The Arcade and 18-20 Corporation Street and 17 Foundry Street, Dewsbury

Summary of Amendments

Doc No. 1705-BDP-AD-XX-RG-Z-00005
Revision: P01
Date: 18 June 2026

DRAWING No.
1705-BDP-AD-00-PL-A-20001-

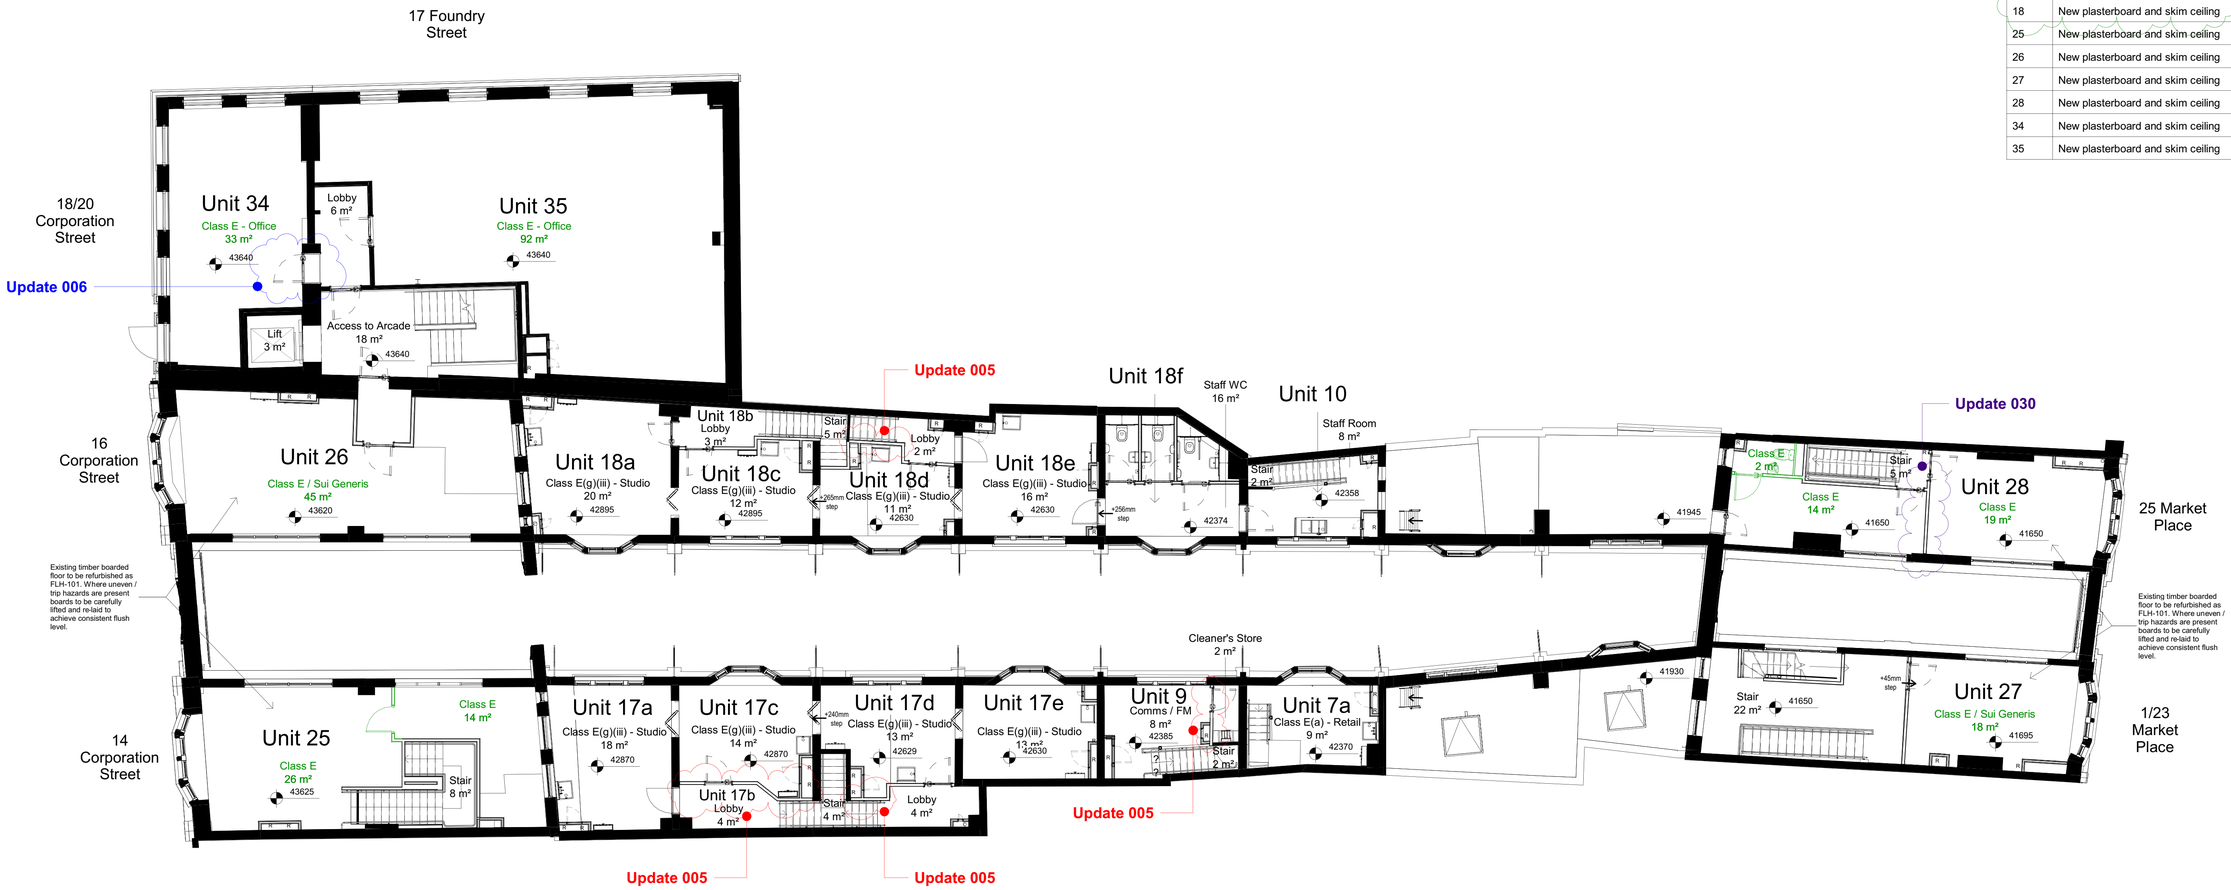
004	**Central Arcade, 14-16 Corporation Street, 18-20 Corporation Street and 17 Foundry Street** Units 3-8, 11-15, 19-24, 32 and 33	Floors	Existing floor slab to be locally removed for new building services and then reinstated.	The floor slabs in these units were found to be several thin layers of poor quality screed directly onto the soil, rather than actual slabs. The overall thickness of these layers was considerably thinner than would have been expected for a proper slab.	It would not be possible to dowel into the existing 'slabs' to reinstate areas of slab following the installation of new building services. This would be likely to lead to differential settlement between the existing areas of slab and the new infill areas.	Remove more of the existing screed layers and install complete slabs to these units, to avoid future differential settlement. This strategy has already had consent in unit 16.	1705-BDP-AD-00-PL-A-20002_T01	1705-BDP-AD-00-PL-A-20002_T02

DRAWING No: 1705-BDP-AD-01-PL-A-20001-

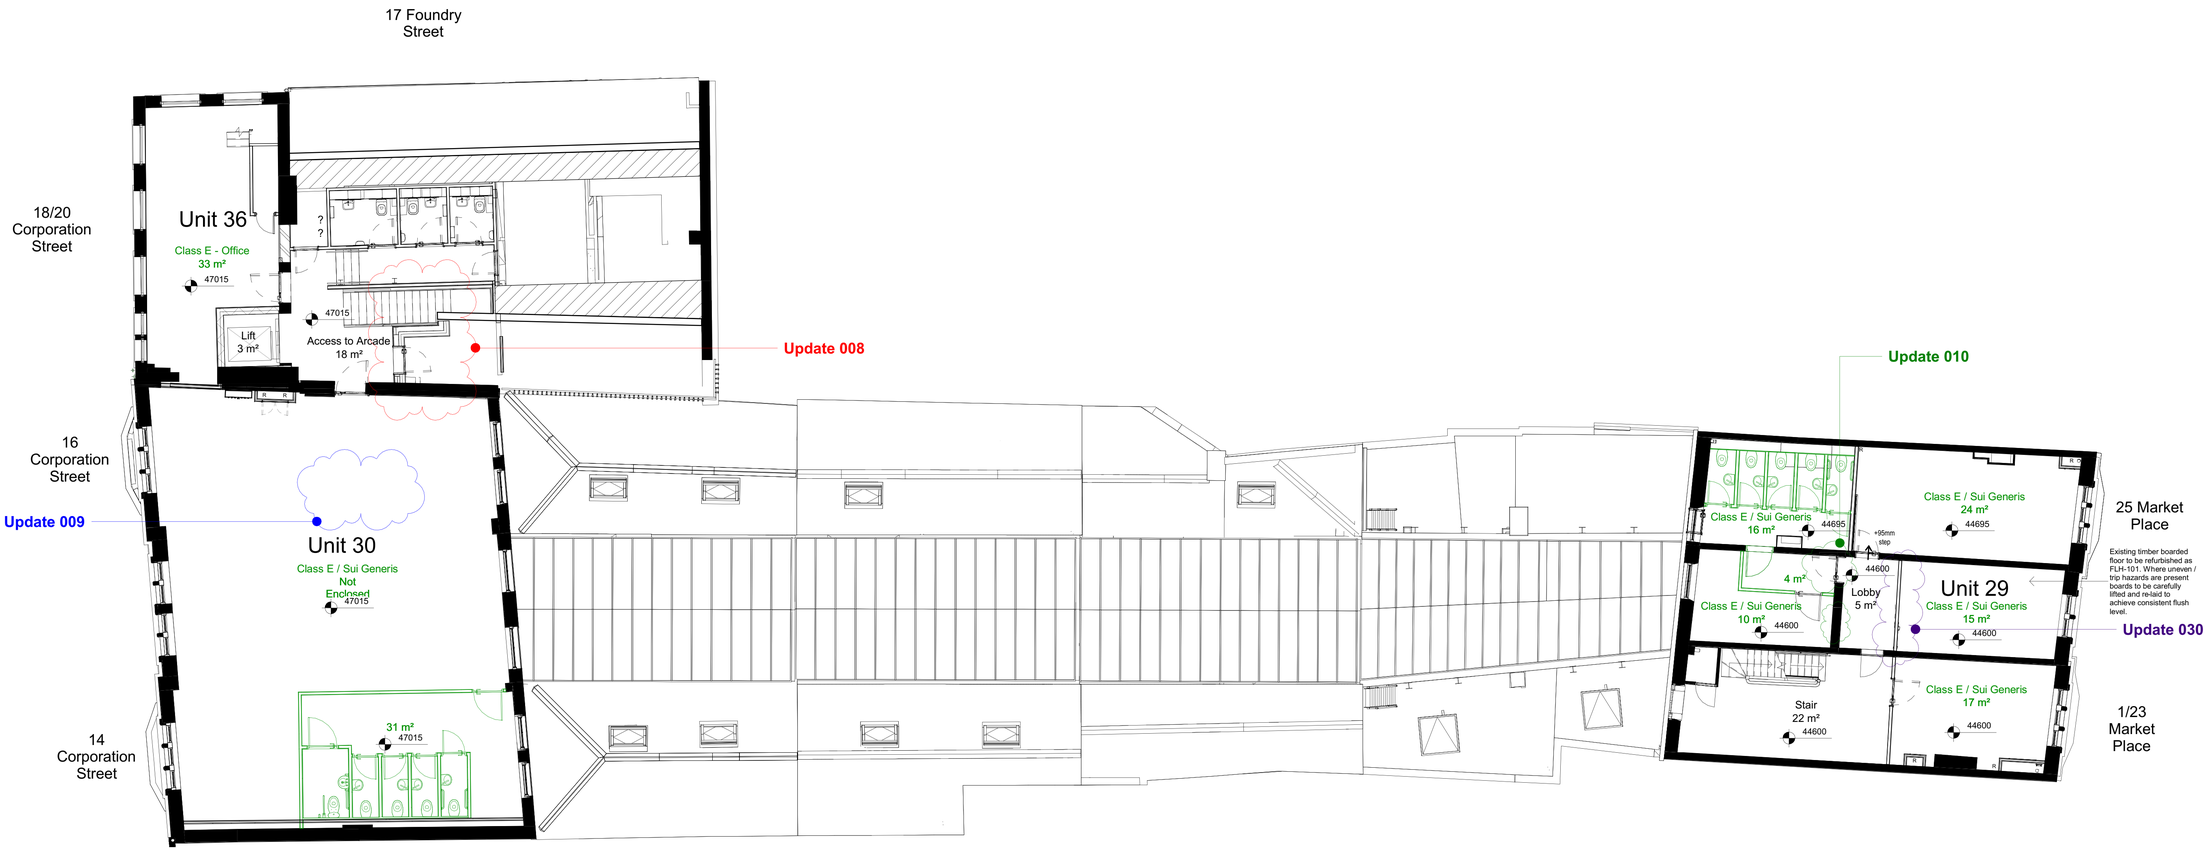
026	**Central Arcade**	Glazed roof structure	Cast iron trusses to be redecorated.	Cracking was noted to the top and bottom chords of several of the cast iron trusses.	The cast iron structure was unsafe in its existing condition.	Install additional steel principal rafters to carry the roof load and relieve the existing cast iron trusses of their existing load. Cast iron trusses to remain in location and be resupported from the new steel rafters.	1705-BDP-AD-RF-PL-A-20005_P01	1705-BDP-AD-RF-PL-A-27001_P02
027	**Central Arcade** Units 7a, 9, 10, 17, 18	Ceilings	Repair damaged lath and plaster ceilings.	The ceilings were found to be in a poorer state than expected.	The plaster had debonded from the laths and therefore was not suitable for patch repair.	Remove damaged material and replace with plasterboard. This approach has already had consent for units 25, 26, 27, 28, 34 and 35.	1705-BDP-AD-01-PL-A-20001_T01	1705-BDP-AD-01-PL-A-20001_T02

Update 007

DRAWING No: 1705-BDP-AD-01-PL-A-20002-

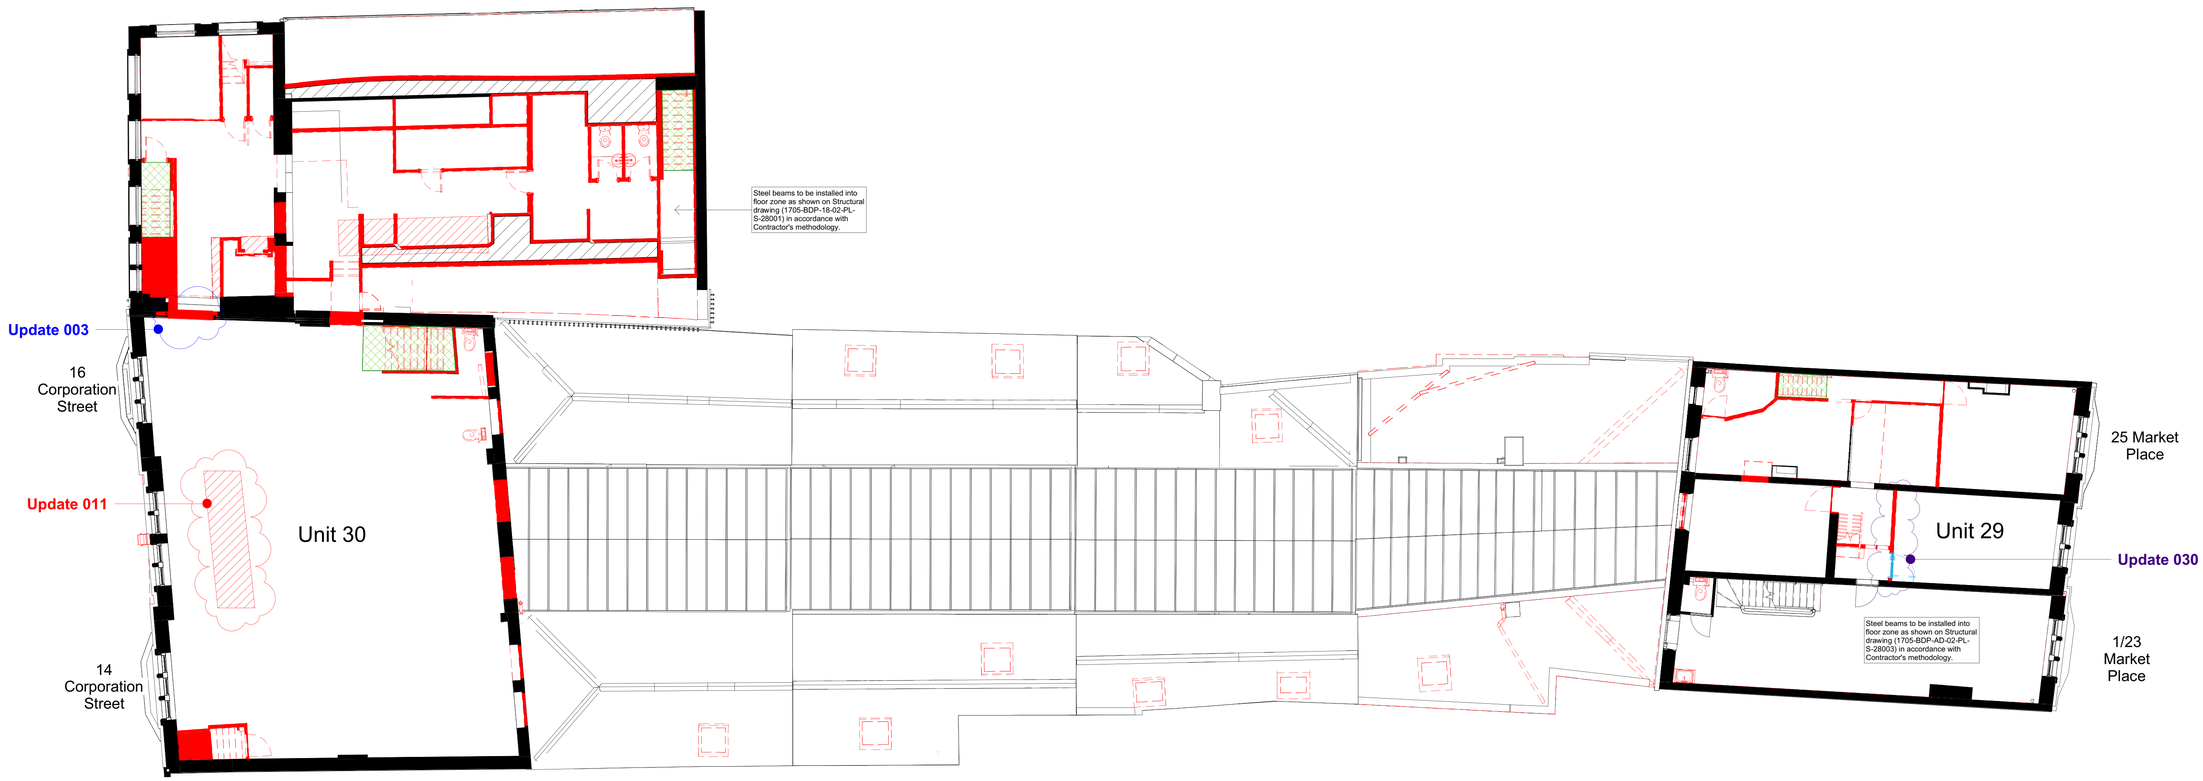
005	**Central Arcade** Units 9 and 17b	Internal partitions	Existing partitions were assumed to be historic lath and plaster partitions to be retained and upgraded to meet the new fire performance requirements for a 60-minute protected stairway where applicable.	The partitions were found to be a mix of more modern construction and were generally poorly built incorporating hard board / MDF.	These were not historic elements of the building, and it would not be practical to upgrade them to provide 60 minute fire resistance.	Replace these sections of partition with new plasterboard partitions to provide the required fire resistance. This is the same approach that had already had consent for the partitions forming the fire-protected stair in unit 18b on the opposite side of the arcade.	1705-BDP-AD-01-PL-A-20001_T01 1705-BDP-AD-01-PL-A-20002_T01	1705-BDP-AD-01-PL-A-20001_T02 1705-BDP-AD-01-PL-A-20002_T02

006	**18-20 Corporation Street and 17 Foundry Street** Unit 34 / 35	Stairwell and door	No lobby to top of stair. New door to swing outwards.	n/a	For building regulations and fire evacuation, it has been proposed that these units should be lobbied from the protected stair, and the door to unit 34 should swing into unit 34, to avoid impacting the escape route from unit 35.	Lobby added. Door to swing inwards (into unit 34)	1705-BDP-AD-01-PL-A-20001_T01 1705-BDP-18-ZZ-PL-A-00002_P06	1705-BDP-AD-01-PL-A-20001_T02 1705-BDP-18-ZZ-PL-A-00002_P07
007	**Central Arcade** First floor units	Floors	Units 17d, 18a, 18b, 18c and 18d: replace the floors due to wet and dry rot. Units 7a, 9, 10, 17a-c, 17e, 18d-f, 25, 26 and 35: Refurbish the floors: lift boards, strengthen and repair existing joist structure. Reinstate existing boards wherever practical and supplement with new.	Extensive wet and dry rot had already been identified in units 17d, 18a, 18b, 18c and 18d, 25, 26 and 35. Further wet and dry rot was found in the remaining units affecting the joists and floorboards.	The existing joists were damaged by wet and dry rot to the extent that strengthening them was not practicable. The floorboards were similarly damaged so that only short lengths could be recovered for reuse.	Replace the timber joist floor structure to the remaining units in the areas that have been affected by wet and dry rot (as had already been had consent for units 17d, 18a, 18b, 18c and 18d). Recover all lengths of floorboard which are suitable for reuse and install them in units 7a and 9, with new floorboards used elsewhere. This will allow two units to retain the appearance of their original floor.	1705-BDP-AD-01-PL-A-20002_T01	1705-BDP-AD-01-PL-A-20002_T02

DRAWING No: 1705-BDP-AD-RF-PL-A-27001-

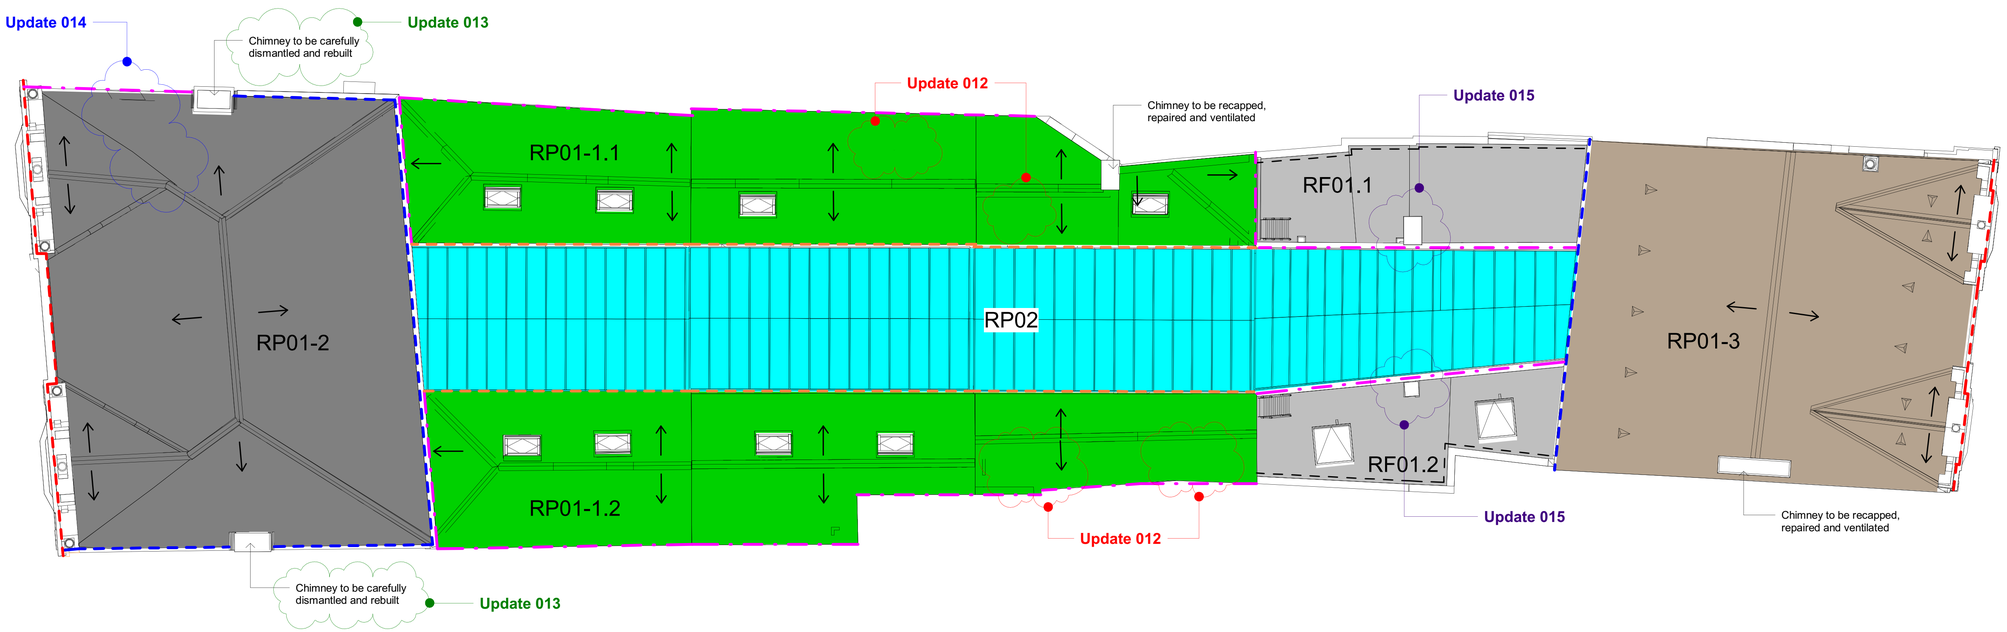
010	**23-25 Market Place** Unit 29	Door opening	Create a new door opening in unit 29 to allow a space to be separated into a corridor and a room.	n/a	Opportunity to omit the new door opening and reuse the existing opening for both the corridor and the adjacent room.	Reconfigure the proposed corridor and omit the new opening in this existing wall	1705-BDP-AD-02-PL-A-20001_T01	1705-BDP-AD-02-PL-A-20001_T02
011	**14-16 Corporation Street** Unit 30	Floor hatch	Retain existing floor hatch.	The floor hatch and the trimming around it was found to be structurally unsafe.	The structural engineer confirmed the existing structure was unsuitable for the proposed building use.	Remove the access hatch and trimming, and infill the area with concrete to tie into the existing concrete (filler joist) floor structure in this area.	1705-BDP-AD-02-PL-A-20002_T01	1705-BDP-AD-02-PL-A-20002_T02
012	**Central Arcade** First floor units	Rooflights	Remove existing rooflights and install a new secure rooflight to each first floor unit in the central arcade area.	The spacing between the existing purlins varies.	The purlin spacing in 4no. of the units is too close to allow a modern secure rooflight to be installed.	Omit 4no. rooflights to units 7a, 9, 18e and 18f. The remaining 6no. rooflights to the other units in this area will still be installed.	1705-BDP-AD-RF-PL-A-20005_P01	1705-BDP-AD-RF-PL-A-27001_P02

013	**14-16 Corporation Street**	Chimneys	The two chimneys were intended to be repointed and recapped.	Following a fingertip survey of the existing, these chimneys were found to be in a poor condition, with suspected sulphate attack to the masonry, causing leaning.	Leaving the chimneys in this condition would pose a safety risk. They would potentially also be a weak point for further moisture to enter the building, and are not easily accessible for ongoing repairs.	Carefully dismantle and rebuild the chimneys straight and plumb, reusing the existing stone wherever possible and supplementing with new to match.	1705-BDP-AD-RF-PL-A-20005_P01 1705-BDP-AD-XX-EL-A-20001_P01 1705-BDP-AD-XX-SE-A-20001_P01	1705-BDP-AD-RF-PL-A-27001_P02 1705-BDP-AD-XX-EL-A-20001_T02 1705-BDP-AD-XX-SE-A-20001_T02
014	**14-16 Corporation Street**	Rooftop walkway	A covered rooftop walkway had been added to connect this roof storage deck to the third floor of 18-20 Corporation Street. This was shown as remaining in location.	This walkway was found to be built using modern materials and was in a poor condition.	Opportunity to remove an inappropriate modern addition and return the profile of the roof to its original state. This is also on the principal elevation of the building, facing onto Corporation Street.	Carefully remove the modern walkway and continue the form of the original slate roof covering over this area of the roof.	1705-BDP-AD-RF-PL-A-20005_P01	1705-BDP-AD-RF-PL-A-27001_P02

023	**17 Foundry Street**	Stairwell	A store was included at the end of the second floor space at the head of the stairwell.	n/a	For building regulations and fire evacuation, it has been proposed that the store room should be omitted.	Omit this store room.	1705-BDP-18-ZZ-PL-A-00002_P06	1705-BDP-18-ZZ-PL-A-00002_P07
024	**18-20 Corporation Street** Units 35 and 36	Floor coverings	Retain existing floor coverings	These floor coverings were found to be Asbestos-Containing Materials (ACMs).	ACMs pose a health risk to the proposed works when they could be disturbed during the refurbishment, and as an ongoing residual risk when they could be disturbed unknowingly for example by future tenants.	Remove these floor coverings to exposed floorboards.	1705-BDP-18-ZZ-PL-A-00002_P06	1705-BDP-18-ZZ-PL-A-00002_P07
025	**Central Arcade**	Glazed roof structure	Timber ridge beams, wall plates and principal rafters to be redecorated.	Extensive wet rot to end bearings of ridge beams and principal rafters. Wet rot to exposed faces of wall plates.	The timber surveyor and structural engineer confirmed the existing timber structure was unsuitable for the proposed roof loading.	Replace the timber with new where decayed, using the same profiles, and decorated to match the existing.	1705-BDP-AD-RF-PL-A-20005_P01	1705-BDP-AD-RF-PL-A-27001_P02
